**ITEM 4.2: Design Review Permit – 751 Roseville Pw. – NIPA PCL 50 - Warehouse – PL21-0210**

The applicant requests approval of a Design Review Permit to allow the construction of a 206,795-square-foot warehouse building and associated site improvements on an approximately 14.05-acre parcel in the North Industrial Plan area.

**Figure 2 – West and South Elevations (facing Foothills Bl. and Roseville Pw.)**

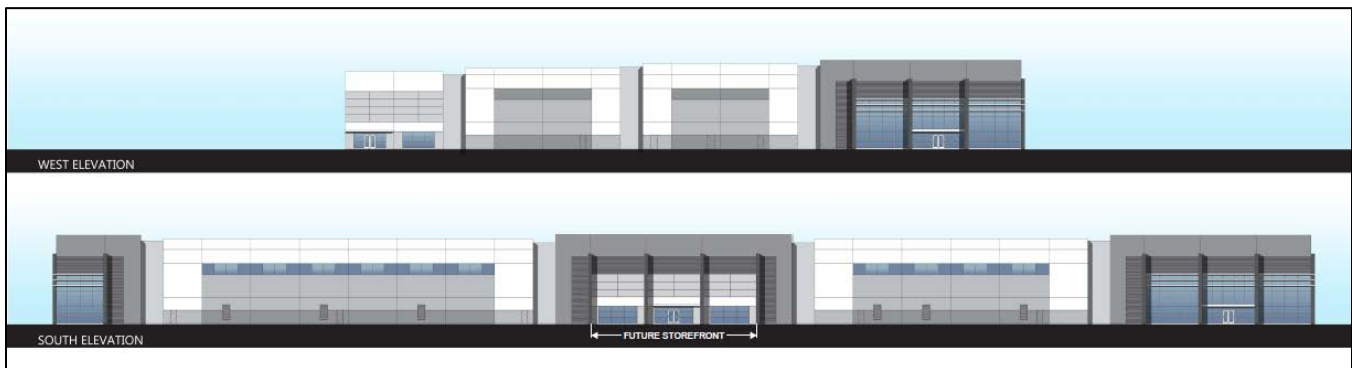
The architecture reflects a functional design that is consistent with the CDG standards for industrial development. The materials include metal awnings, glass, and aluminum framing, and include a color palate of blues, greys, and whites. The design incorporates score lines into the concrete tilt up panels to break up the façade for visual interest. Furthermore, design orients the more visually engaging office locations, which include the aluminum framing and spandrel glass, towards the future Roseville Pw., while the truck dock locations are along the north (rear) of the building. Overall, the proposed design is consistent with the guidelines and policies outlined in the CDG and NRADG.
